BCA Report for Development Application

Project Name	Redevelopment of an existing boarding house.
Project Address	61-63 Bradley Street, Goulburn NSW 2580
Ref	VBS24-9681
Rev	2 (FINAL)
Date	11 December 2024
Attention	Simon Hekeik Yarrabee Property Group

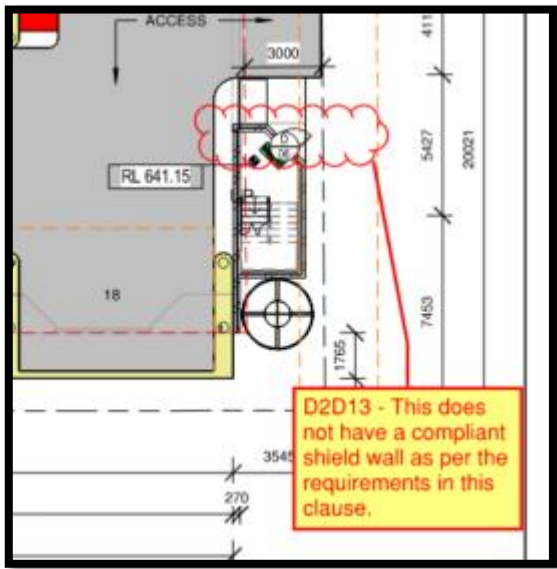
Clause	Assessment Comments	Status
Travel via fire-isolated exits D2D12 (D1.7)	1) A doorway from a room must not open directly into a stairway, passageway or ramp that is required to be fire-isolated unless it is from— a) a public corridor, public lobby or the like; or b) a sole-occupancy unit occupying all of a storey; or c) a sanitary compartment, airlock or the like. 2) Each fire-isolated stairway or fire-isolated ramp must provide independent egress from each storey served and discharge directly, or by way of its own fire-isolated passageway— a) to a road or open space; or b) to a point— i. in a storey or space, within the confines of the building, that is used only for pedestrian movement, car parking or the like and is open for at least $\frac{2}{3}$ of its perimeter; and ii. from which an unimpeded path of travel, not further than 20 m, is available to a road or open space; or c) into a covered area that— i. adjoins a road or open space; and ii. is open for at least $\frac{1}{3}$ of its perimeter; and iii. has an unobstructed clear height throughout, including the perimeter openings, of not less than 3 m; and iv. provides an unimpeded path of travel from the point of discharge to the road or open space of not more than 6 m. 3) Where a path of travel from the point of discharge of a fire-isolated exit necessitates passing within 6 m of any part of an external wall of the same building, measured horizontally at right angles to the path of travel, the following applies: a) That part of the wall must have— i. an FRL of not less than 60/60/60; and ii. any openings protected internally in accordance with C4D5; and b) The protection required by (a) must extend for a distance of 3 m above or below, as appropriate, the level of the path of travel, or for the height of the wall, whichever is the lesser. 4) If more than 2 access doorways, not from a sanitary compartment or the like, open to a required fire-isolated exit in the same storey— a) a smoke lobby in accordance with D3D7 must be provided; or b) the exit must be pressurised in accordance with AS 1668.1. 5) A ramp must be provided at any change in level less than 600 mm in a fire-isolated passageway in a Class 9 building. <u>COMMENTS</u> The Fire Isolated Stair discharges within 6m of the building for the length of travel to the road.	Performance solution required
